RE: Response to EPA Letter dated March 25, 2009
The Sherwin-Williams Company (February 18, 2009) Response to EPA Letter dated January 14, 2009 EPA's Comments on the *"Revised" Route 561 Dump Site Ground Water Contour Maps* (dated August 29, 2008)

The Sherwin-Williams Company Sites – RI/FS Activities
Gibbsboro, New Jersey
Administrative Order Index No. II CERCLA-02-99-2035

TITLE: Dump Site
Proposed Monitoring Well Location Map
(January 14, 2009 EPA Comment Letter)

TITLE: Dump Site
Revised Proposed Monitoring Well Location Map
With Pore Water Locations
(March 25, 2009 EPA Comment Letter)

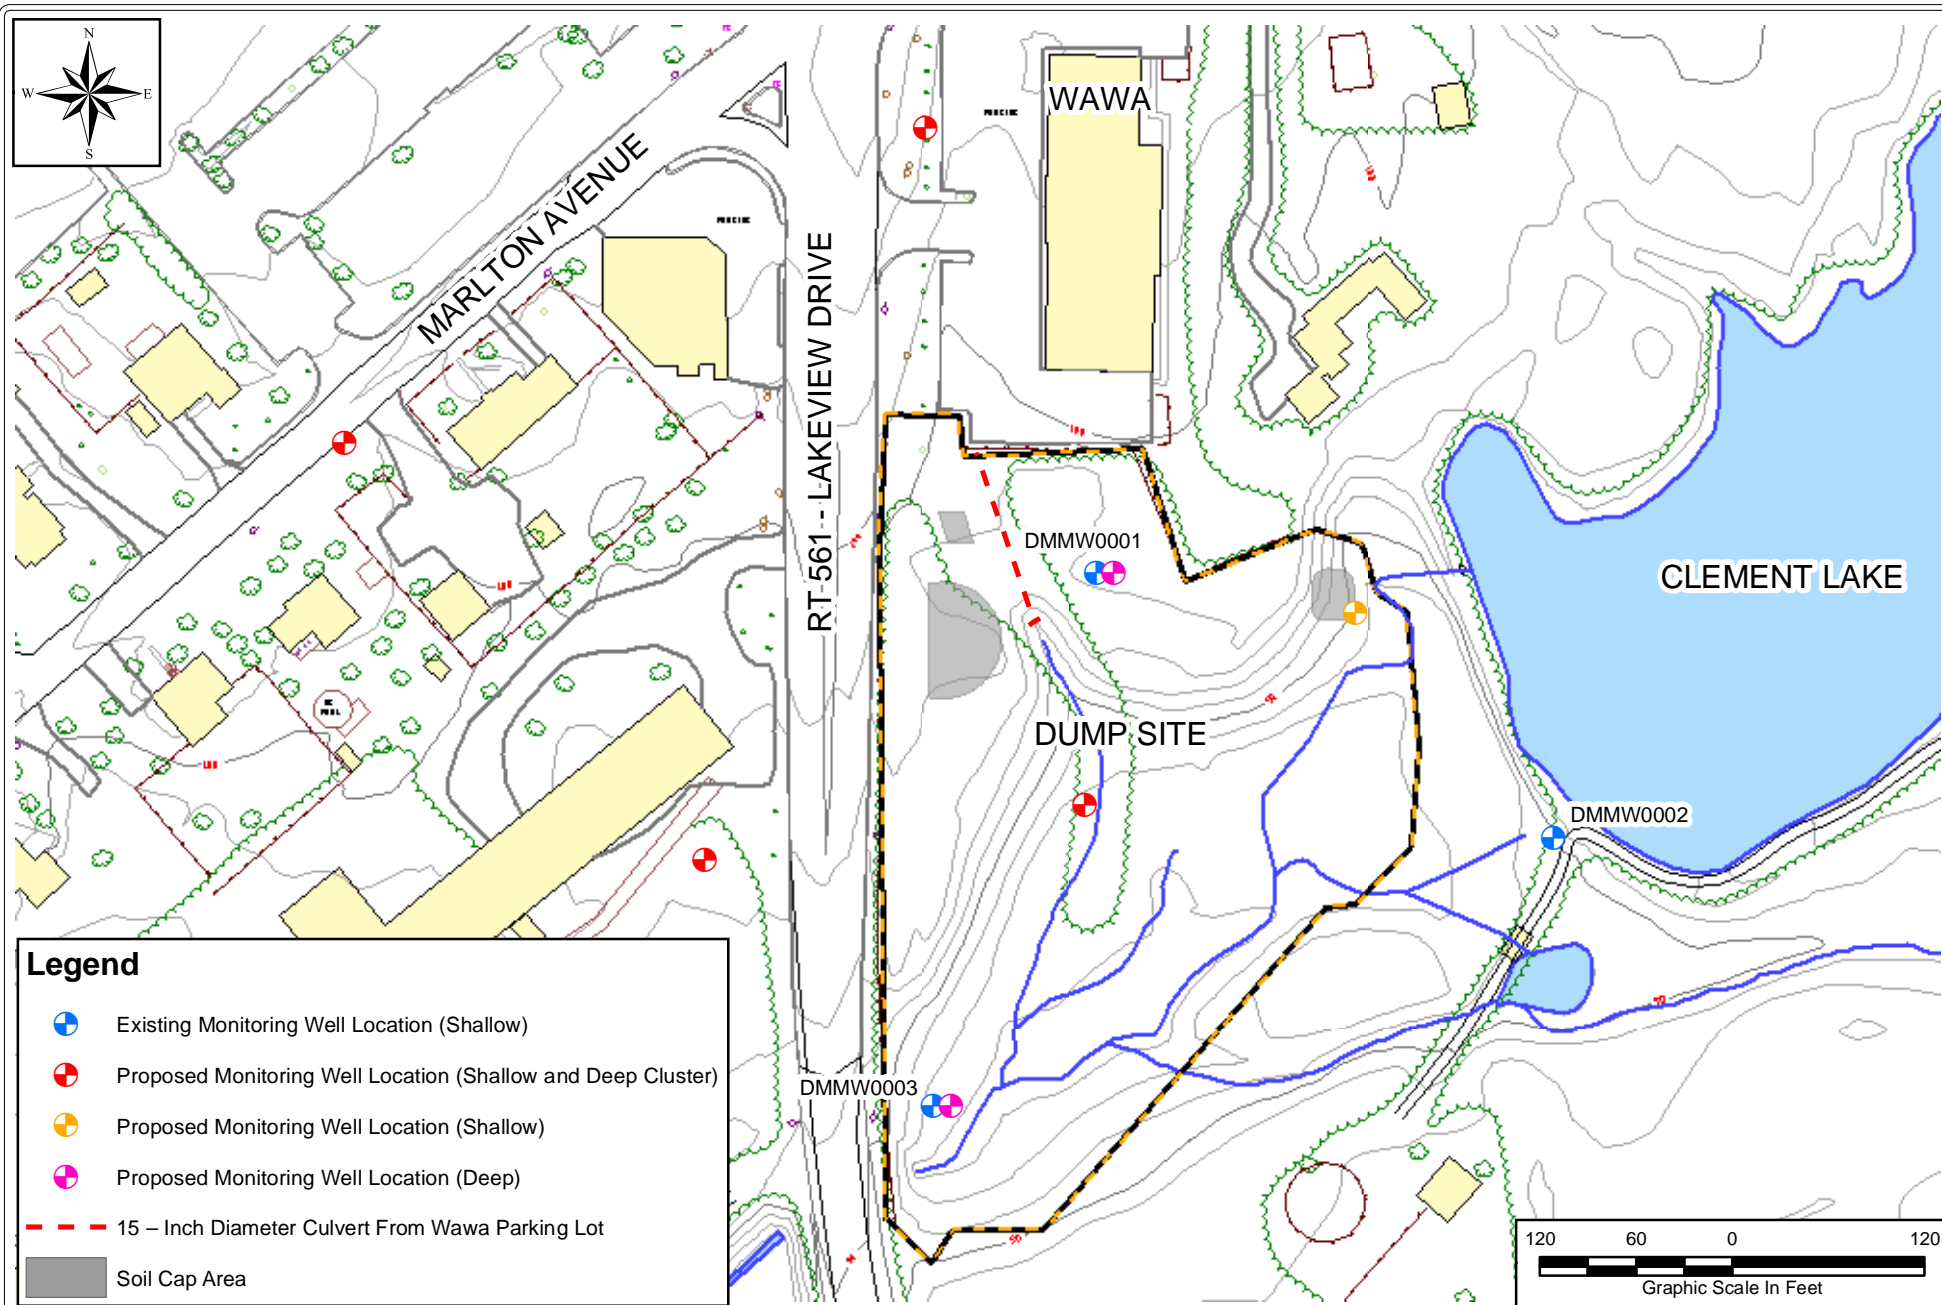
Presently, there are three shallow wells located within the Dump Site fenced area that were installed during the RI activities conducted in July 2005. As discussed during the December 18, 2008 Gibbsboro project meeting, EPA is recommending 11 new wells be installed to supplement the three existing shallow wells.

These 11 wells are comprised of four well couplets, two deep wells and one shallow well. The four well couplets are proposed at three off-site locations in addition to one location within the Dump Site. The two deep wells are intended to be co-located at existing shallow well locations (DMMW0001 and 0003) to form couplets. There is one shallow well proposed within the fenced area near the northeastern fence line adjacent to Clement Lake. These locations are presented on the attached Figure 1.

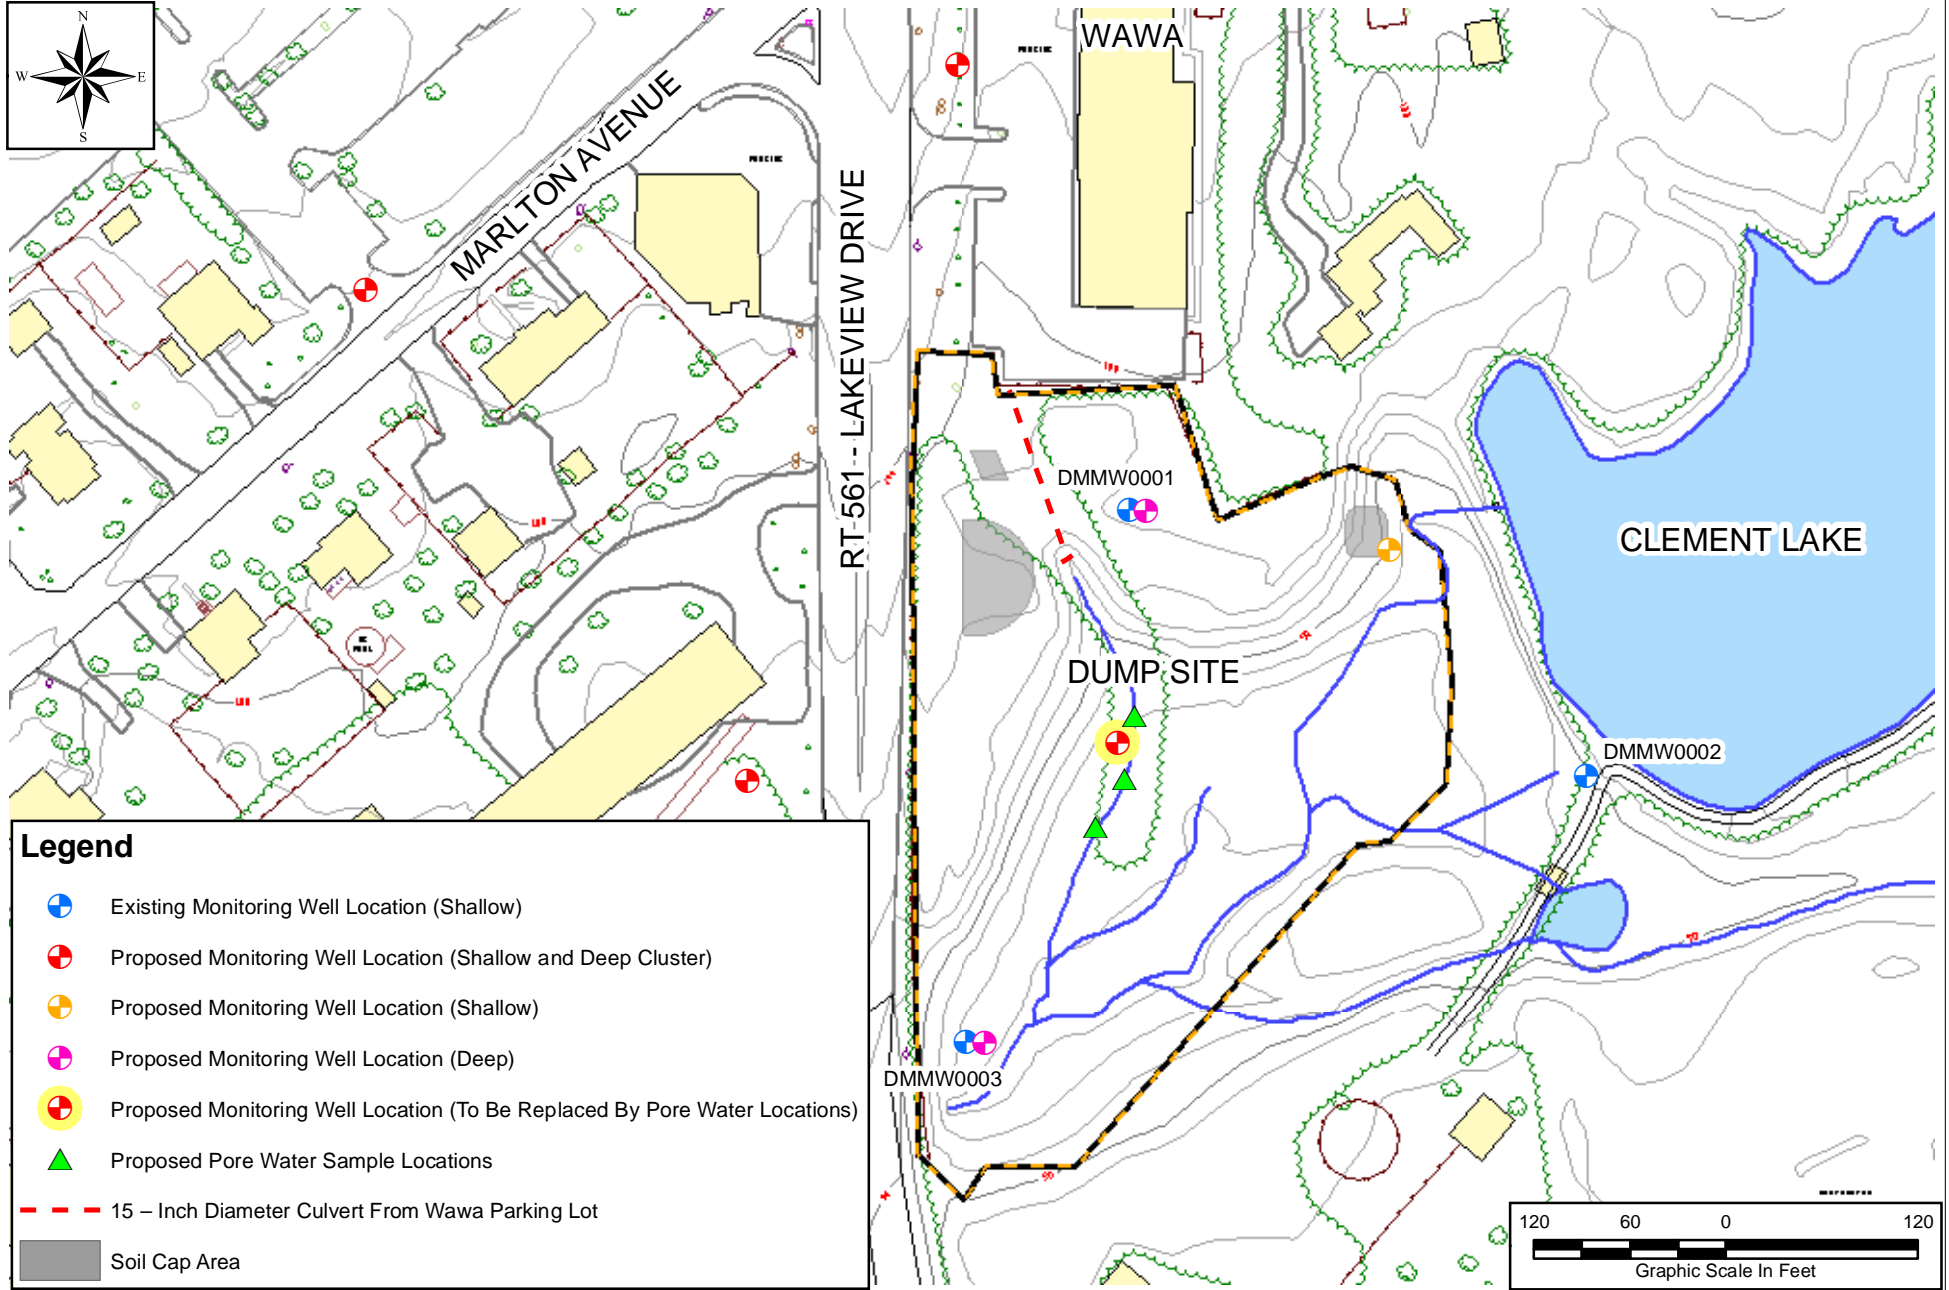
On March 25, 2009, Ray Klimcsak (EPA) along with Patrick Austin and Arthur Fischer (both Weston Solutions, Inc. [Weston®]) inspected the proposed locations that Weston and the drilling subcontractor (ECDI) marked out the previous week. Due to accessibility issues, there were three locations identified that would require the proposed monitor well locations to be shifted. They are as follows:

- Due to the proximity of underground and overhead utilities, it is suggested that the proposed well cluster on Marlton Avenue be shifted approximately 30 feet from the south side of the street to the north side of the street.
- Due to the proximity of a large tree, the proposed well cluster next to the Medical Arts Building (across Route 561 from the Dump Site) will need to be shifted approximately 10 to 20 feet in a northeasterly direction towards Route 561.
- Due to its location in an inaccessible area of the wetlands (soft, wet soils), it is suggested that the proposed well cluster in the middle of the site (near the base of the slope where the culvert from the Wawa parking lot runs) be shifted upslope approximately 50 feet to a more accessible, stable area.

As a result of this site walk, EPA concurred with the re-location of the well clusters located on Marlton Avenue and next to the Medical Arts Building. However, in lieu of the monitoring well cluster in the middle of the site (near the intermittent stream), EPA is requesting that three or four pore water samples be collected along the intermittent stream. These revised monitor well and pore water locations are presented on the attached Figure 2.
